**SERVICE BULLETIN NUMBER CT 125 including MODIFICATION M186
ISSUE 1 PAGE 1 of 6**

TITLE	Fuel System
CLASSIFICATION	The CAA have classified this bulletin as Mandatory.
COMPLIANCE	Fuel flow check before further flight. Modify system within 25 hours or 6 months, whichever is earlier.
APPLICABILITY	All UK registered CT2K aircraft.

Fig 1 Tee pieces installed approximately 100mm above the top of the tunnel.

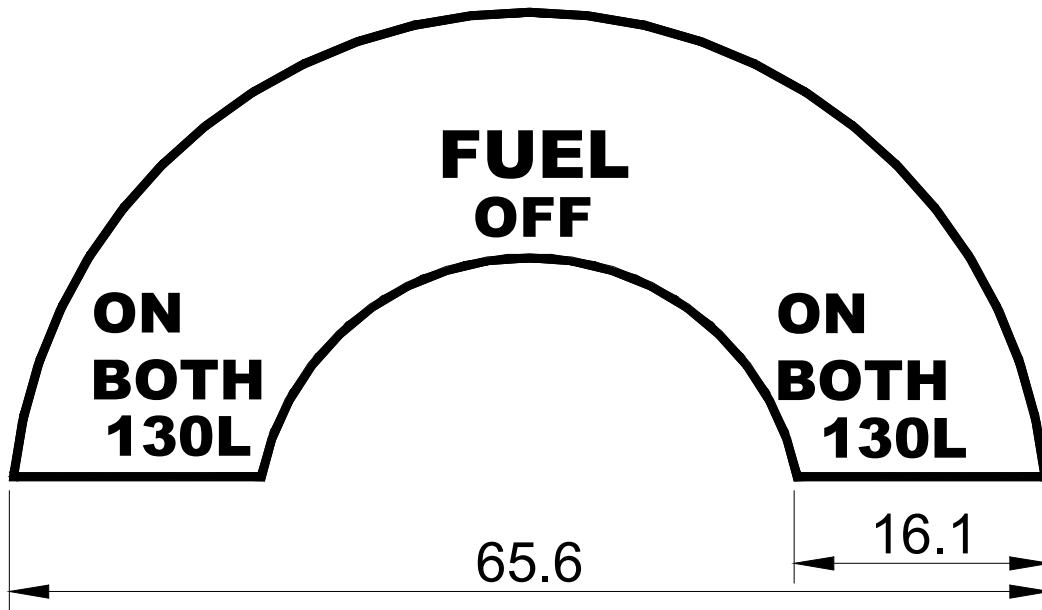
- 2.0) Remove central console panel upper section. For improved access, remove both instrument panels.
- 2.1) Clamp off the feeds from the two wing tanks.
- 2.2) Cut the two tank feed pipes approximately 100mm above the top of the fuselage tunnel and fit 2 tee pieces with a link tube between them (see fig 1).
- 2.3) The fuel tank vents must be replaced with vent caps having square cut bottom edges, so as to create the same pressure at each tank vent, as in fig 2.
- 2.4) The fuel tank selector placard must be replaced with the type shown in fig 3.
- 2.5) Check fuel feed and valve function as in (1) above, test the valve in all 3 positions. Check all joints for leaks.
- 2.6) Check any disturbed wiring etc. is correctly routed and clear of rudder cables.
- 2.7) Refit panels.

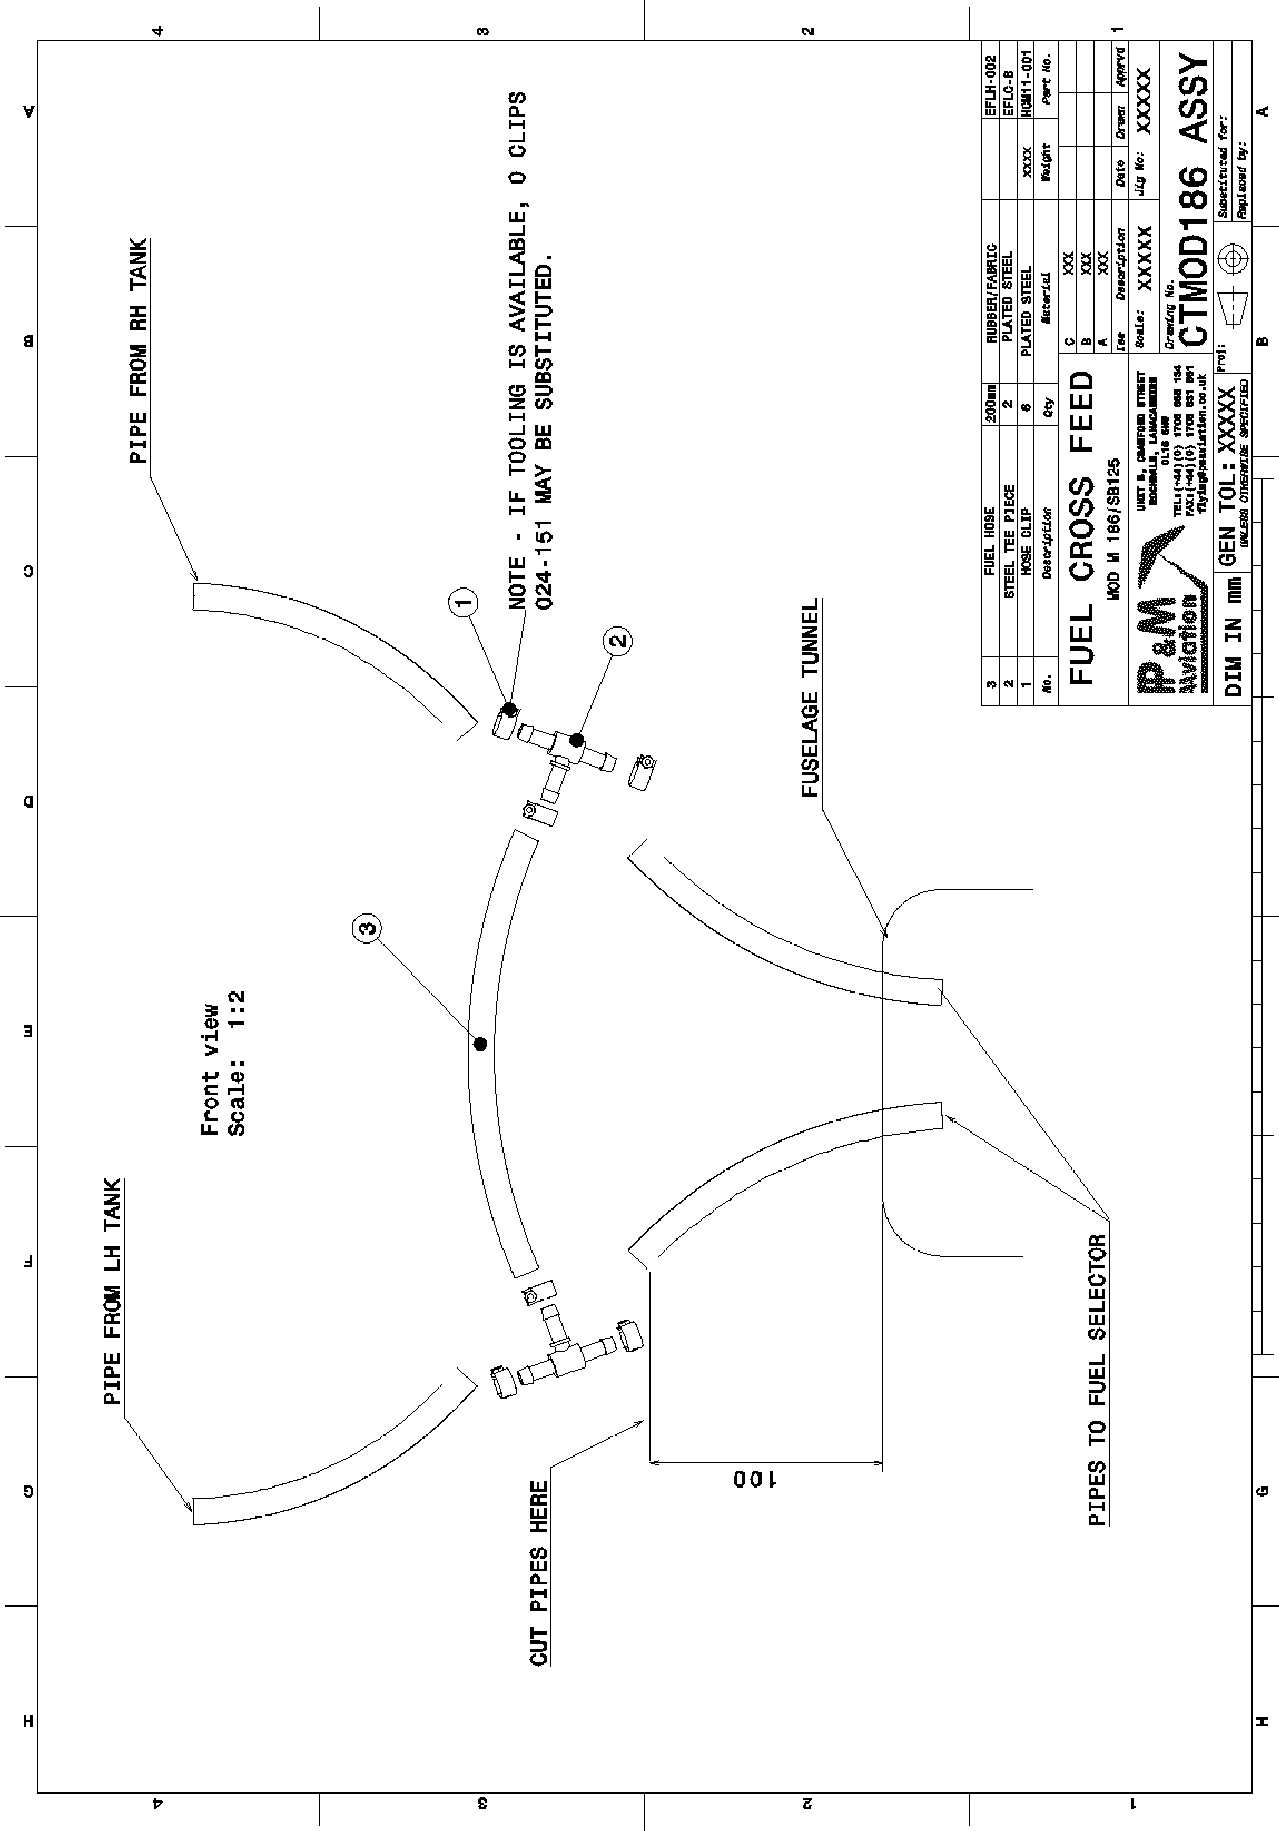
Modification M186 has been introduced to interconnect the wing tanks using two tee pieces.

The modification kit comprises a link tube, 2 steel tee pieces, six hose clamps and a fuel selector placard. See drawing CTMOD M186 ASSY.

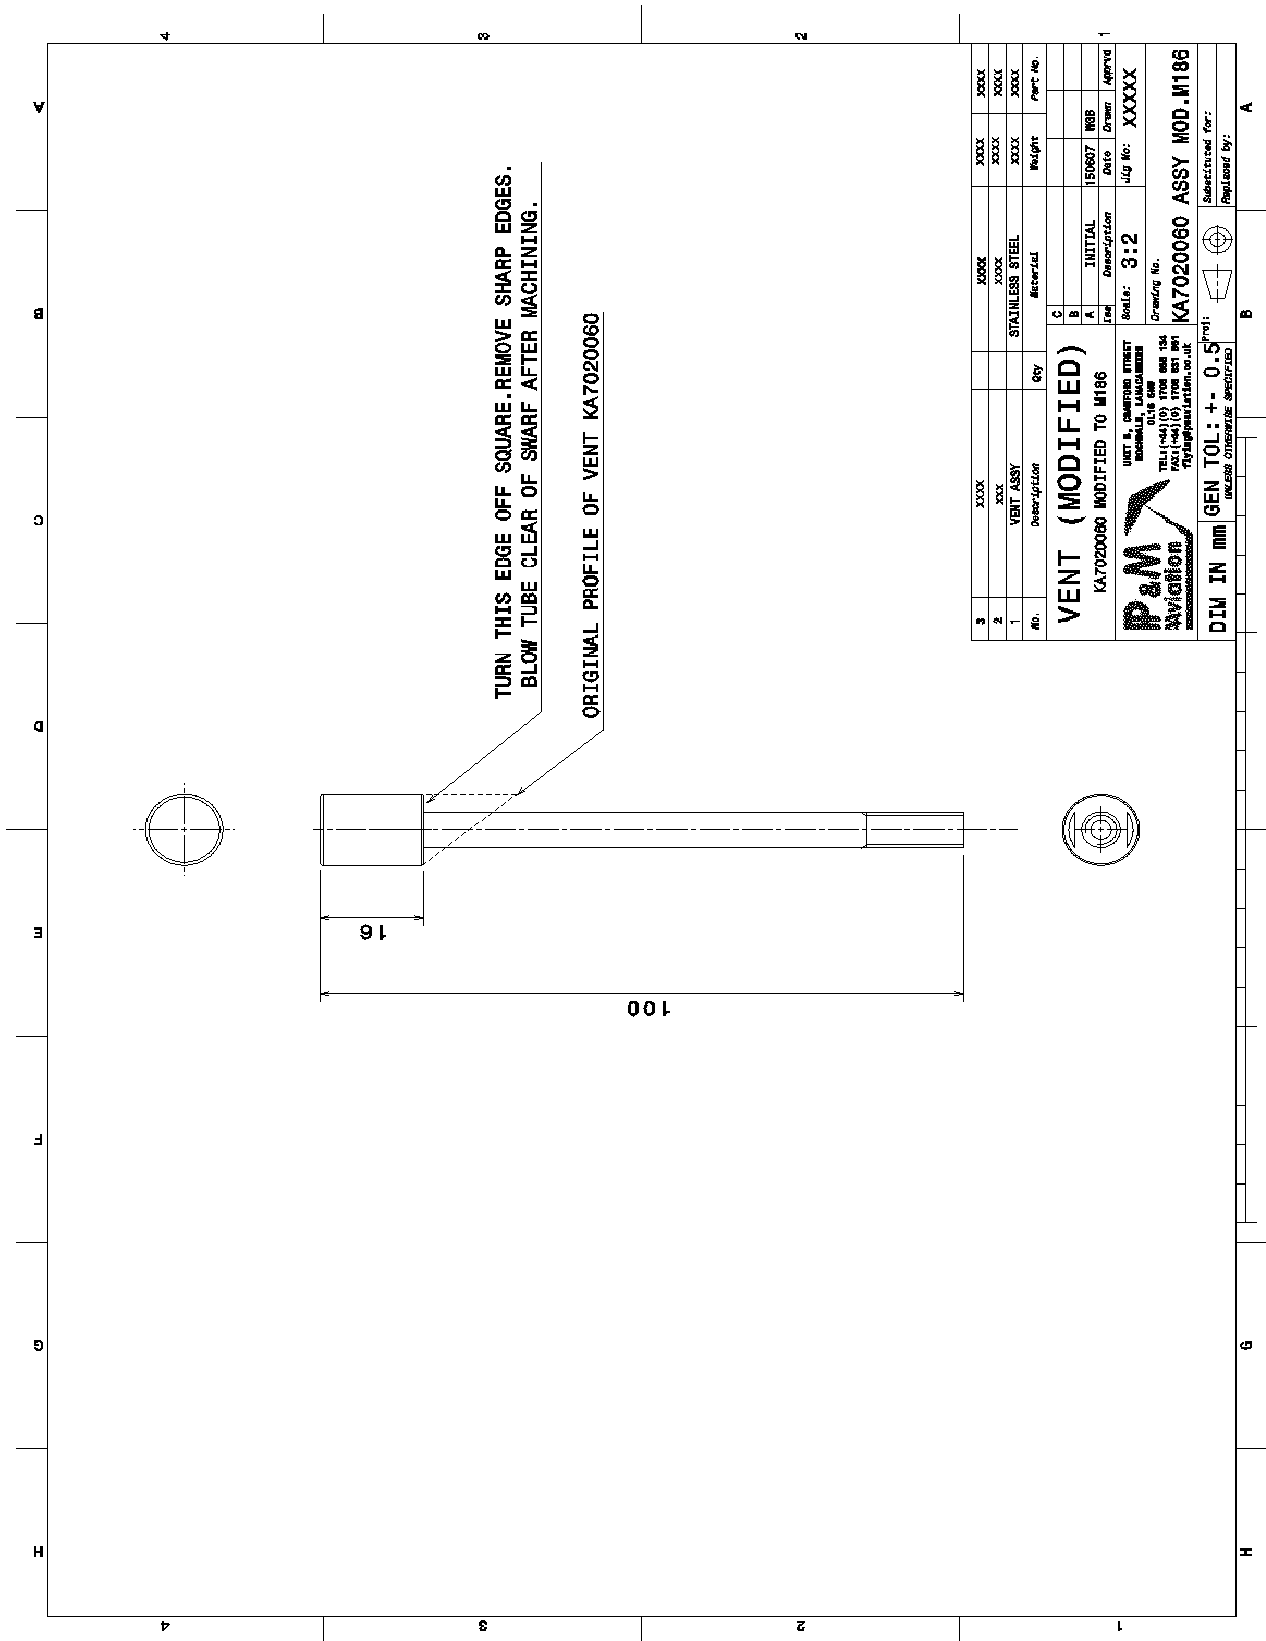
Both fuel cap vent bottom edges must be exchanged for those with square cut lower edges. See drawing KA7020060 ASSY MOD M186.
